DECISION DOCUMENT

TWENTY-TWO NO FURTHER ACTION SITES

SENECA ARMY DEPOT ACTIVITY
ROMULUS, NEW YORK 14541

Response to Regulatory Agency Comments:
NO FURTHER ACTION SITES REPORT

FIGURE 2-1
NO ACTION SITES

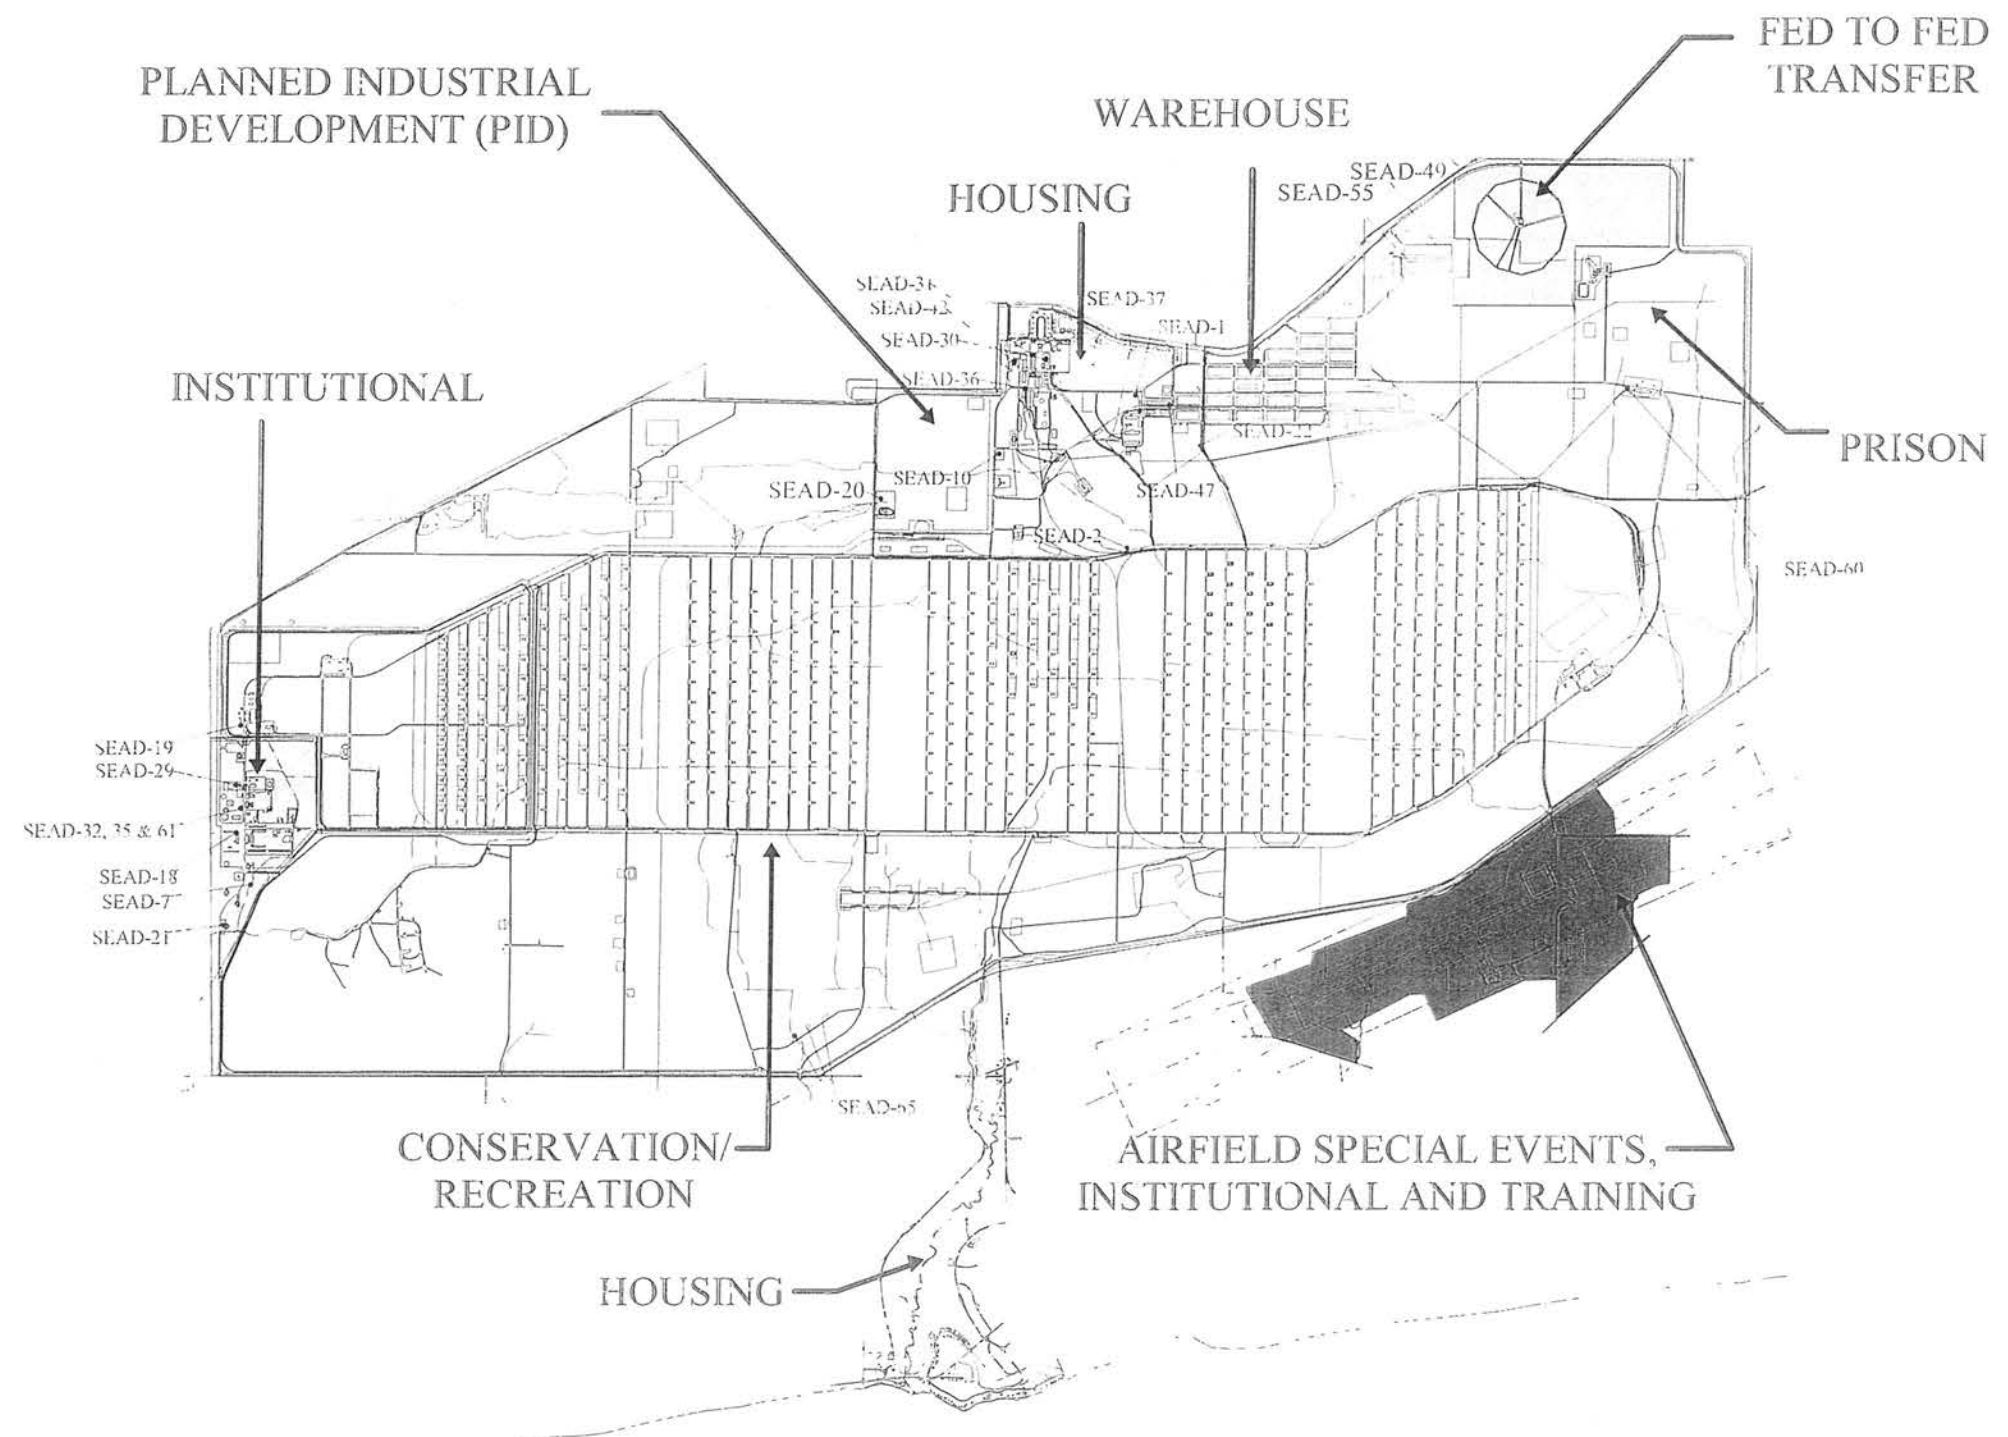
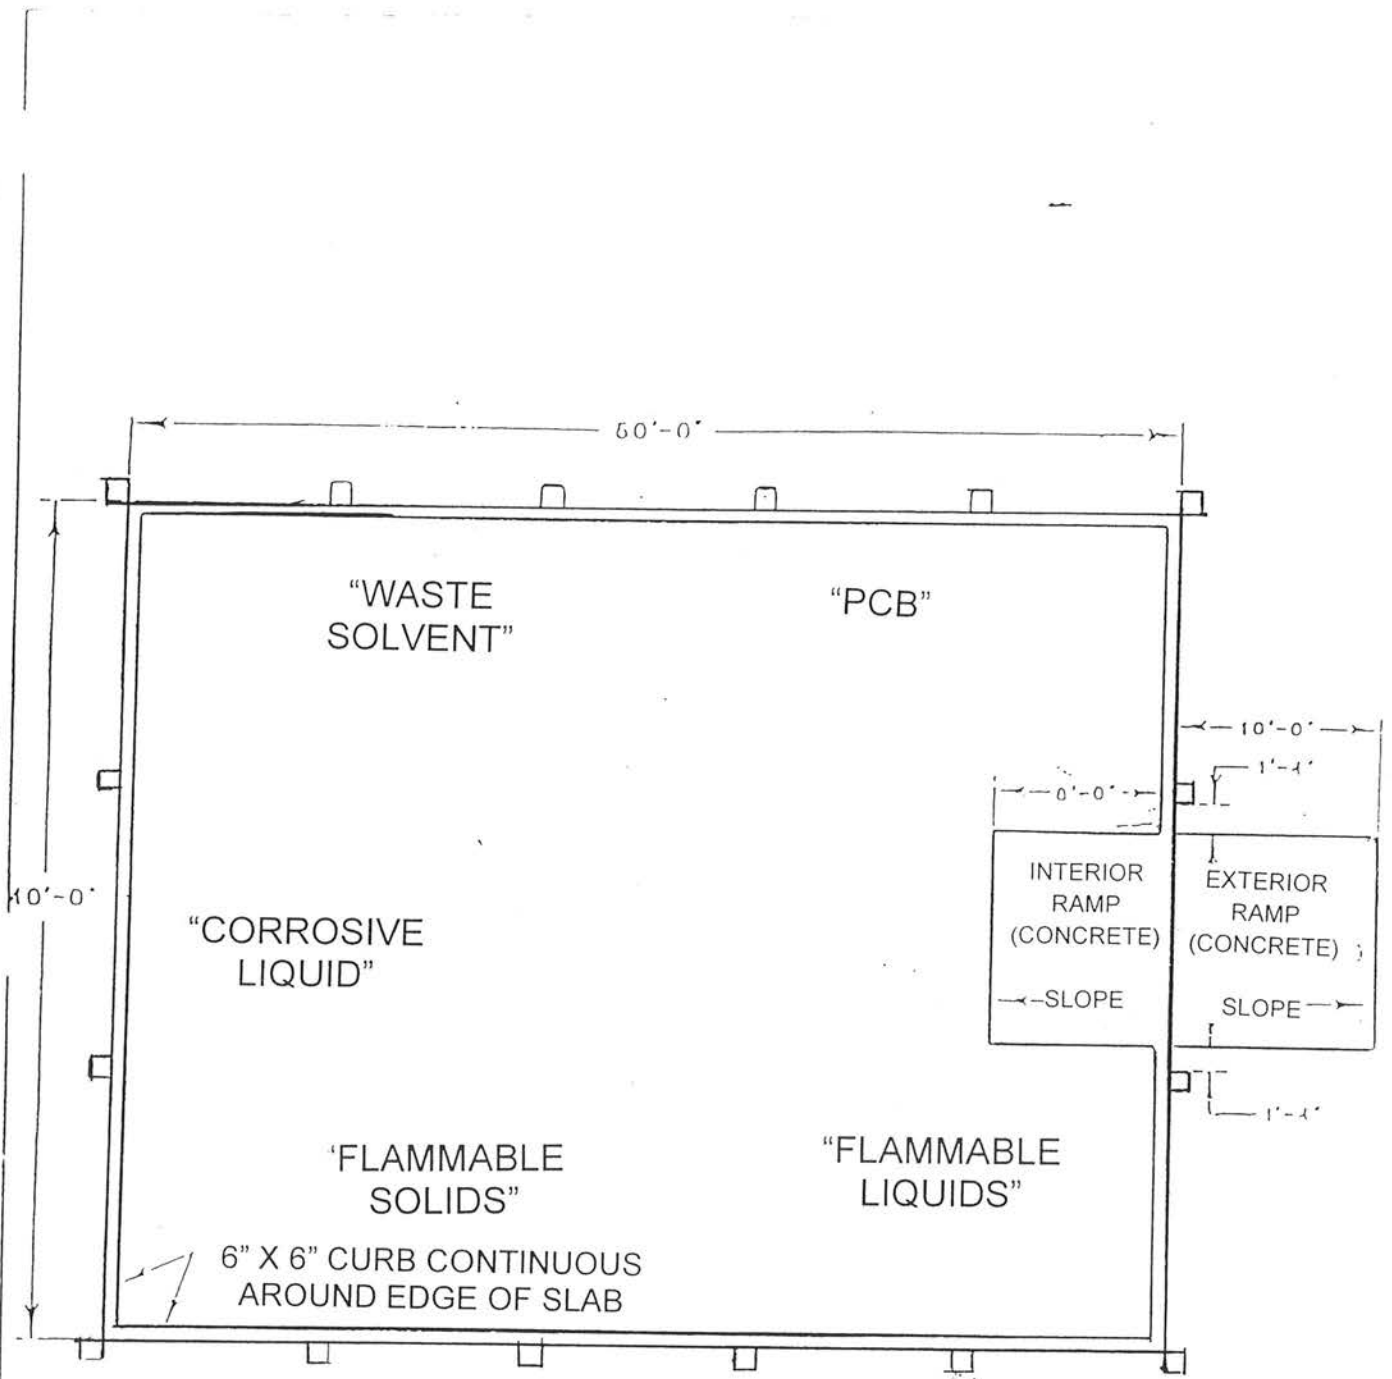
1. There seems to be a typographical error on the number for the first figure of Chapter 2. Referenced Figure 2-1 cannot be found in the document. Please include more specific maps for the different areas (i.e.. North End, PID, Warehouse, Q, etc.).

Agree. The typographical error has been corrected. Additional figures are being added to the document per your request.

PLAN VIEW OF BUILDING 106
MEDICAL - DENTAL CLINIC

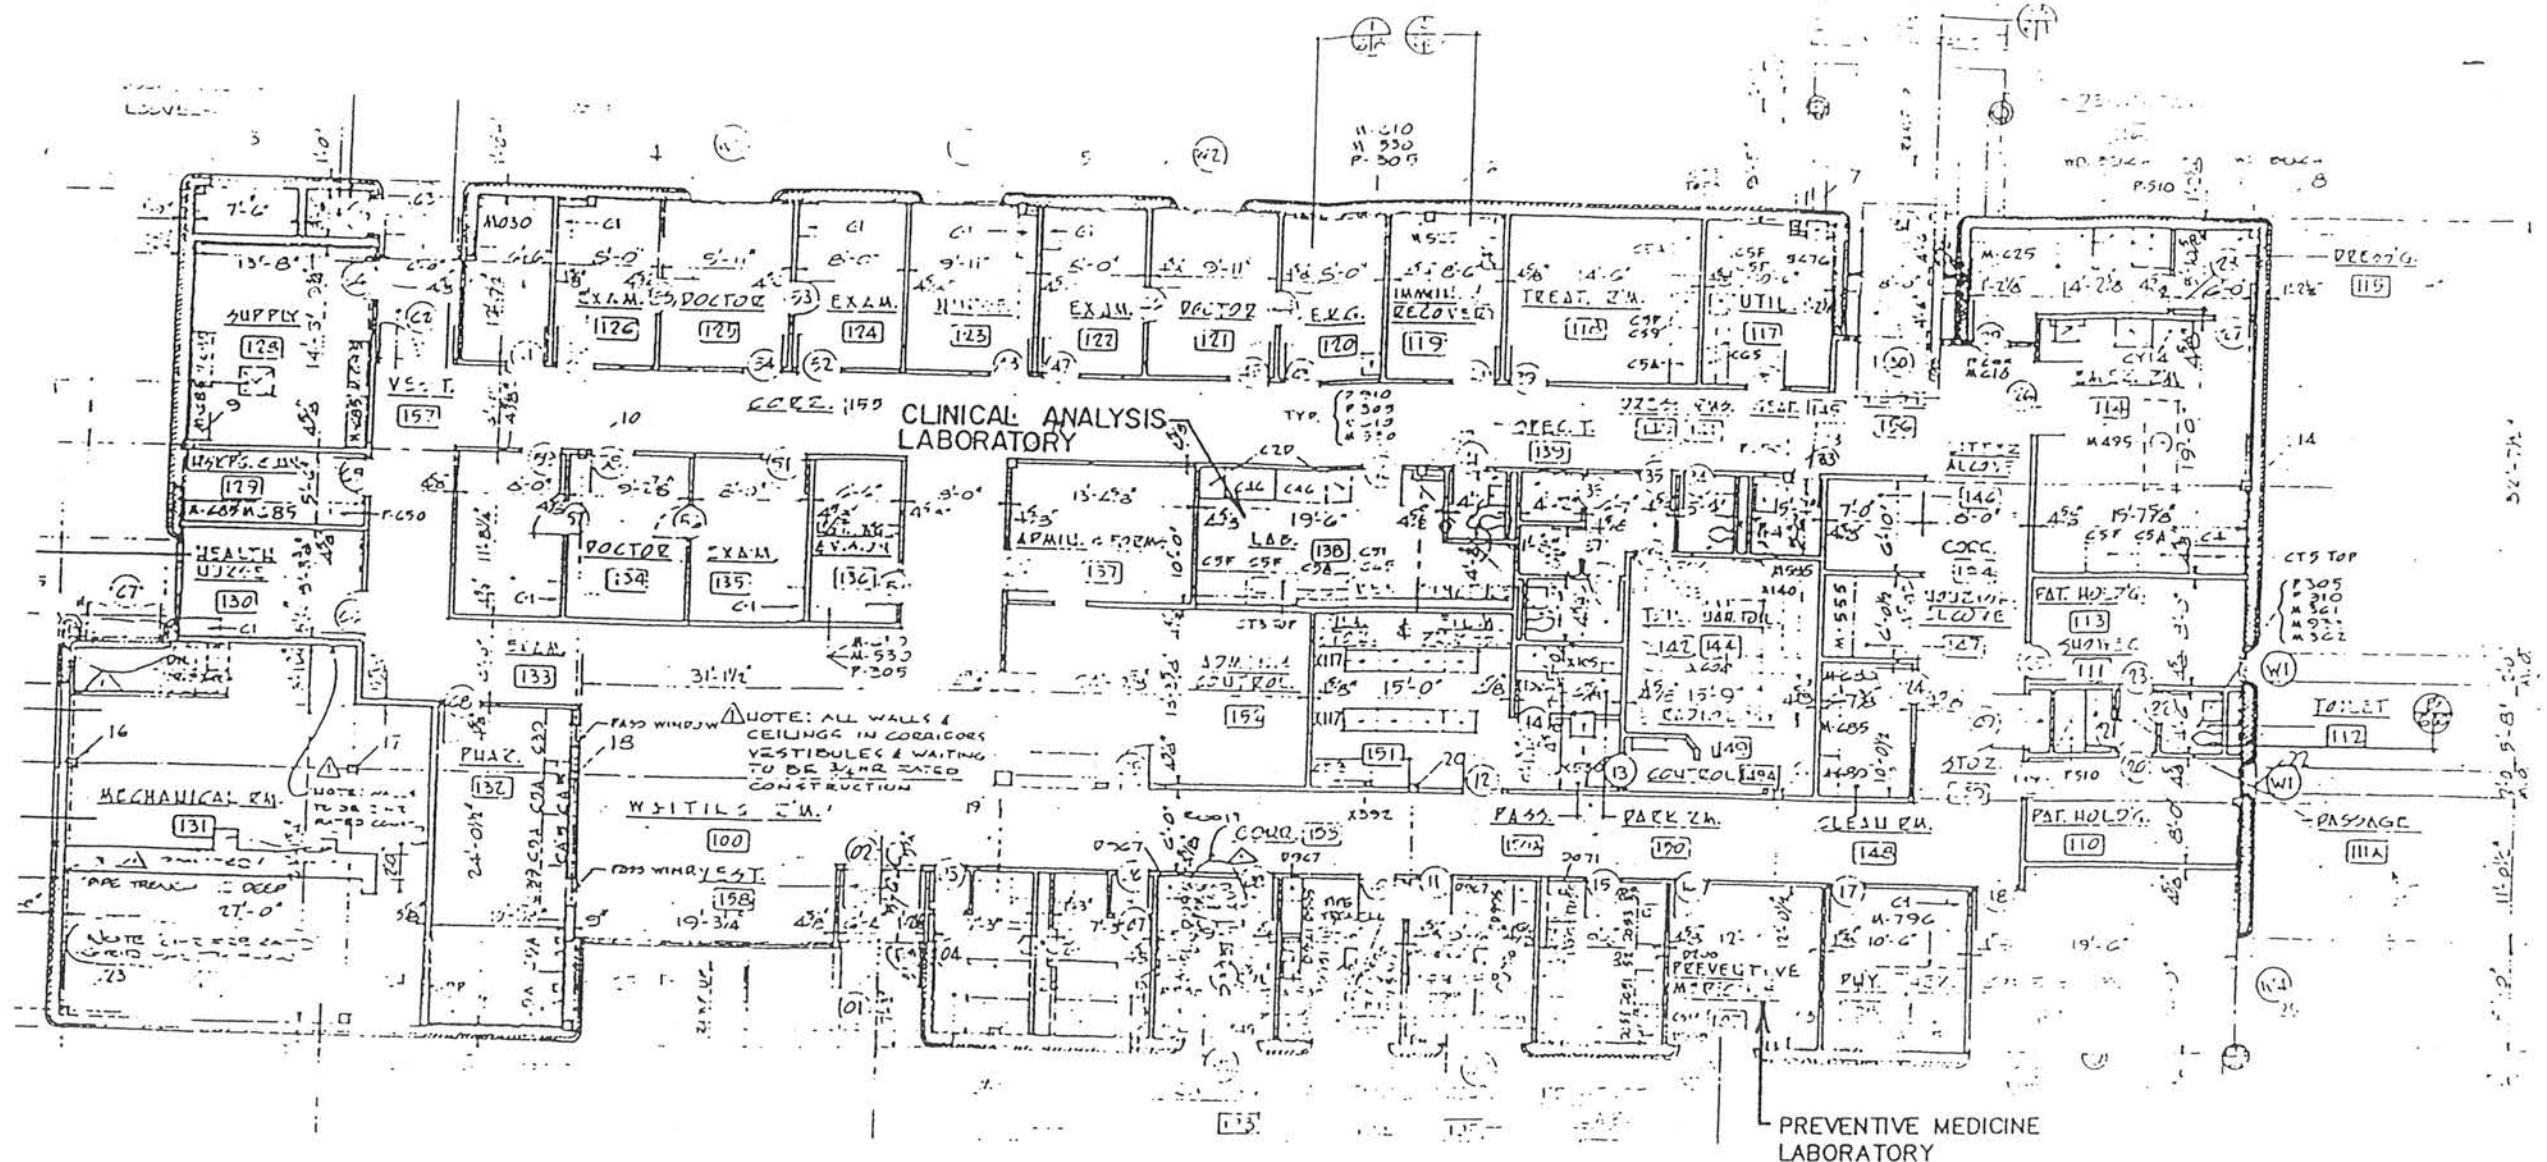
Page 2-26, Section 2.17.2: According to Figure 2-5, the Preventative Maintenance Laboratory was located in the northwest portion of Building 106, not the northeast, as indicated in the text in this section. The Clinical Analyses laboratory would then be located southeast of the Preventative Maintenance Laboratory.
